PROJECT NAME: Former Chevron Station 91026

CONCEPTUAL SITE MODEL ADDENDUM AND CLOSURE REQUEST

FORMER CHEVRON STATION 91026
3701 BROADWAY
OAKLAND, CALIFORNIA
AGENCY CASE NO. RO0000500

Subject: Request for Data Gap Work Plan and Focused Site Conceptual Model; Fuel Leak Case No. RO0000500 (Global ID # T0600100334), Chevron #9-1026, 3701 Broadway, Oakland CA 94611

Figure 3
 POTENTIAL RECEPTORS
 FORMER CHEVRON STATION 91026
 3701 BROADWAY
 Oakland, California

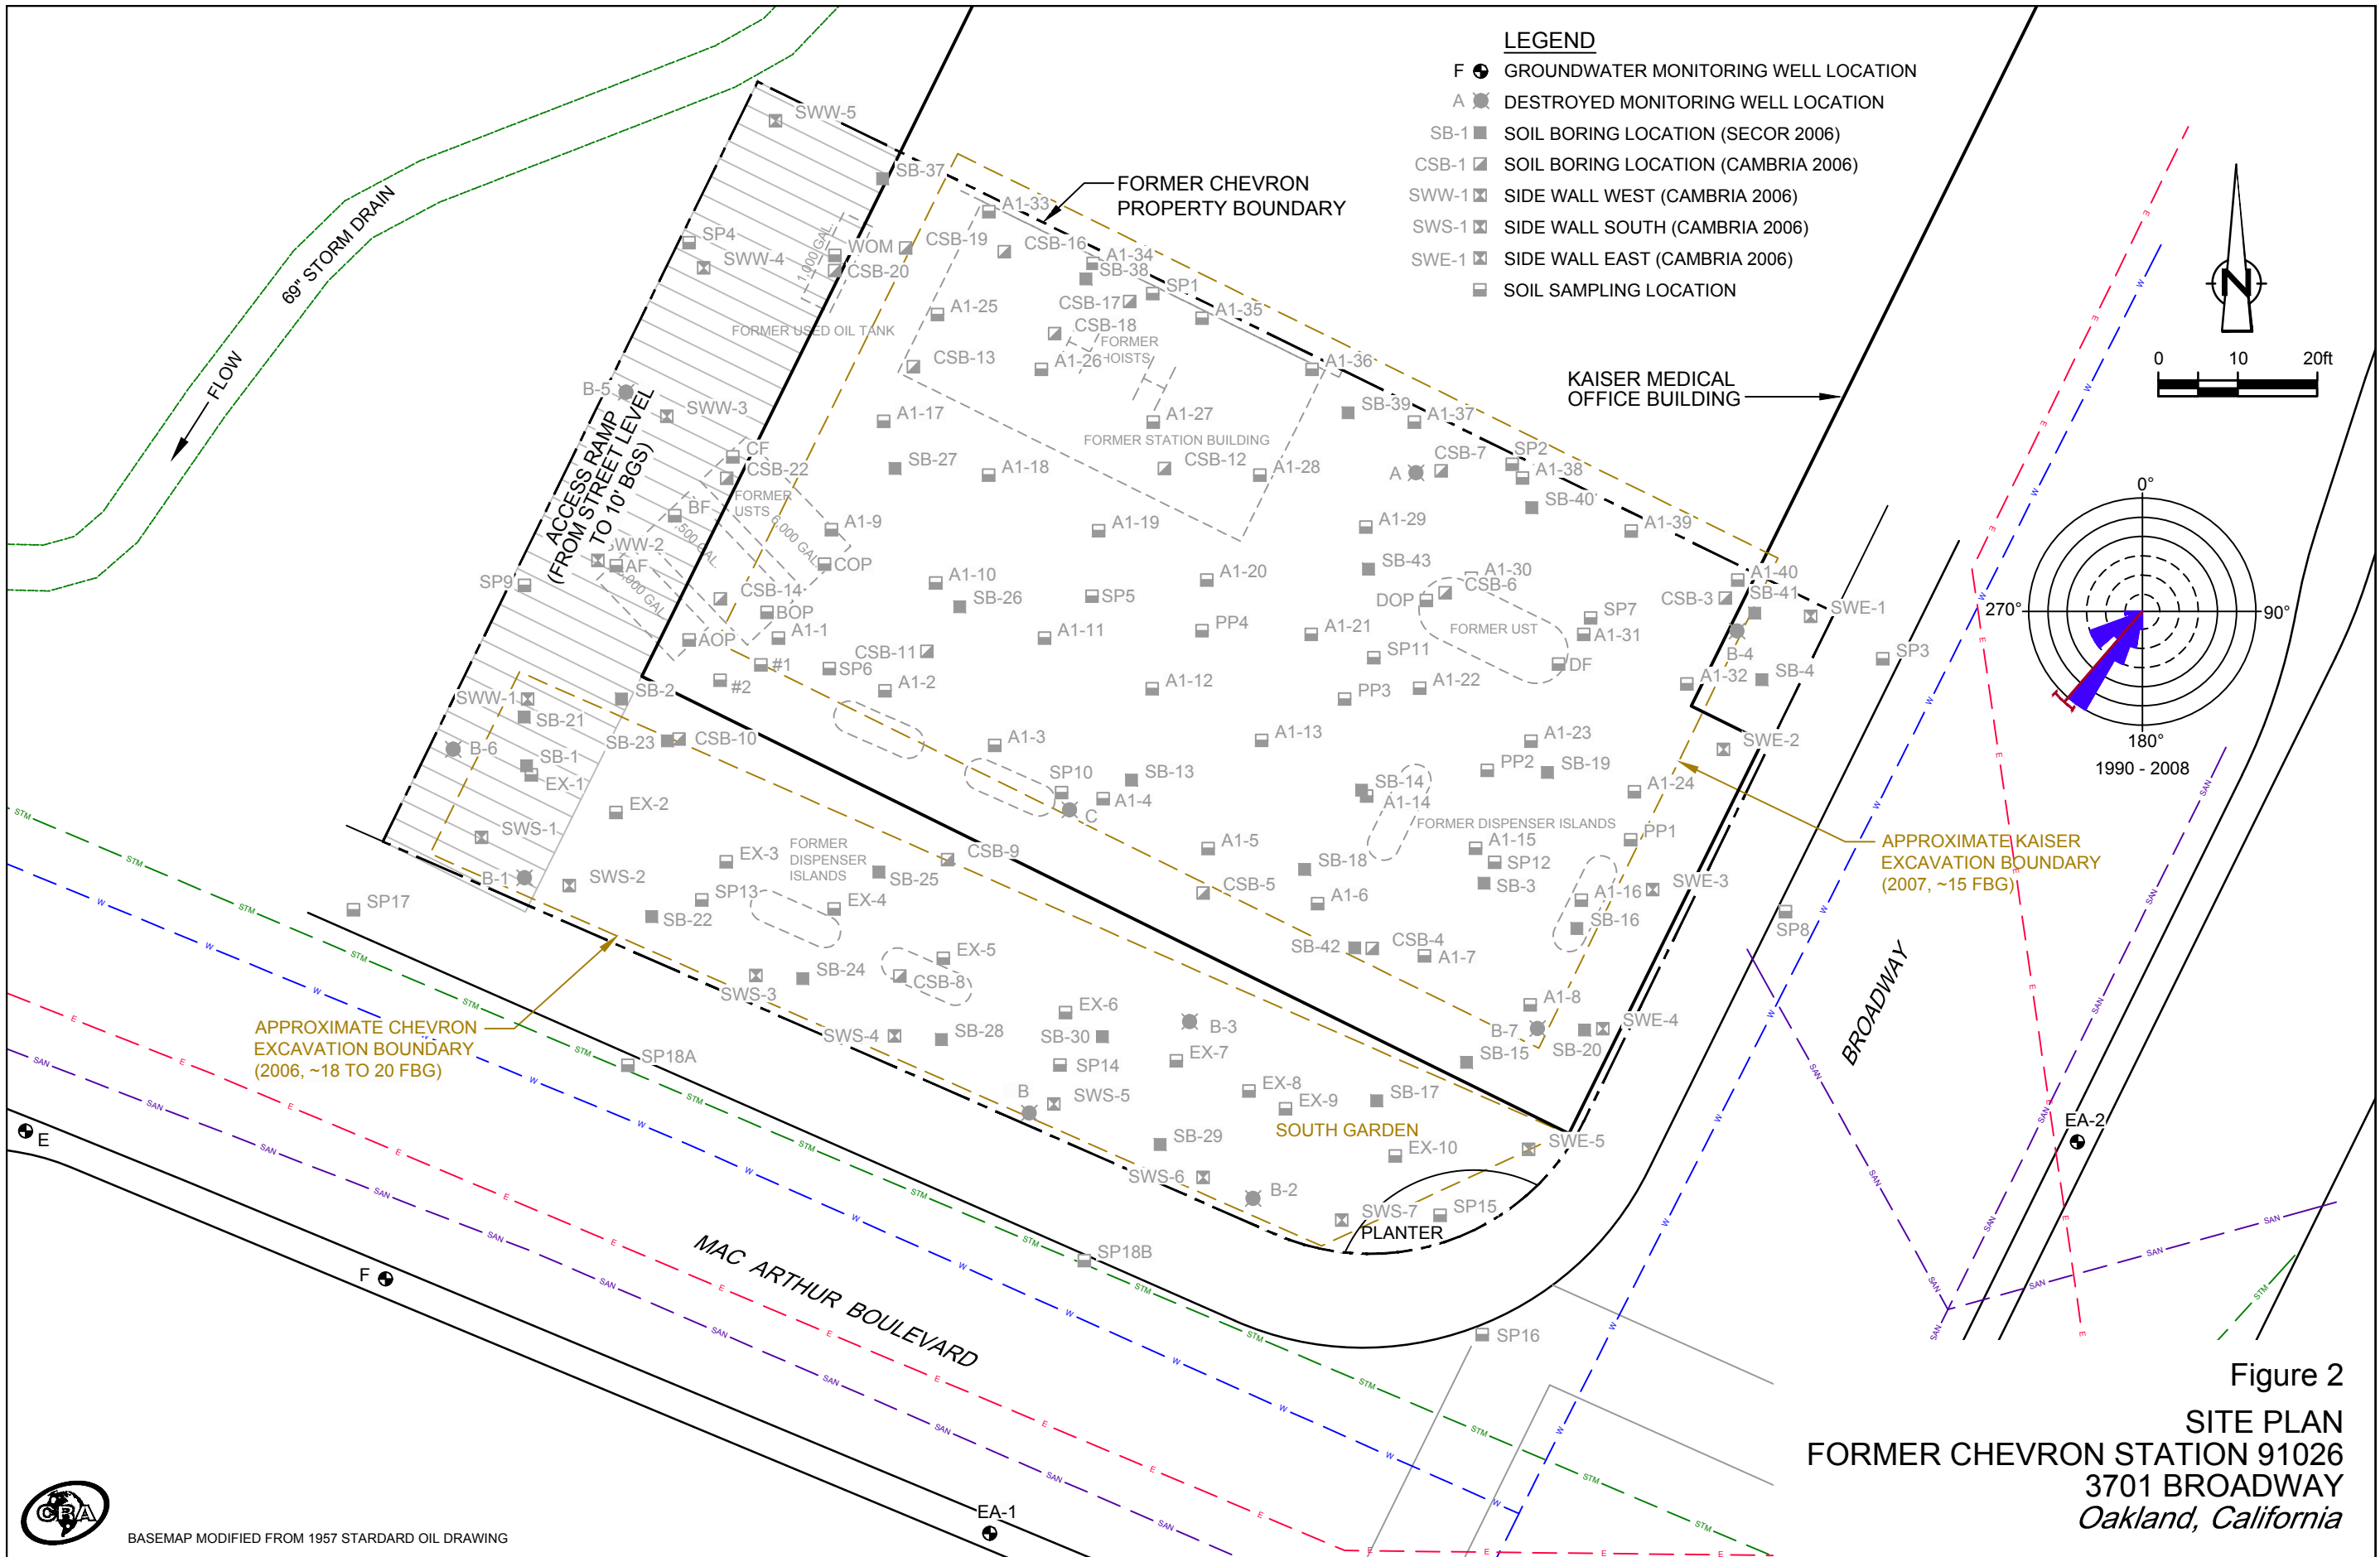
- d. **Vicinity Water Supply Well Survey** – The referenced report indicated that the Geotracker Groundwater Ambient Monitoring and Assessment (GAMA) database was reviewed to determine if water supply wells are located within 1,000 feet of the subject site. ACEH views the database as a starting point for well surveys as it does not contain the complete datasets maintained by the Department of Water Resources (DWR) and the Alameda County Public Works Agency (ACPWA). These databases contain additional information about privately owned waters supply wells in the vicinity. Consequently, ACEH requests these resources also be included in a well survey for the site.

CRA has compiled well data provided by California Department of Water Resources (DWR) and by Alameda County Public Works Agency (ACPWA). Based on well data from the two agencies, there are no wells located within 1,000 feet of the site. There is one irrigation well located approximately 1,900 feet upgradient. The water supply well and sensitive receptors are listed in Table 1 and located on Figure 3 and one pre-school that is located just outside of the 1,000 feet radius.
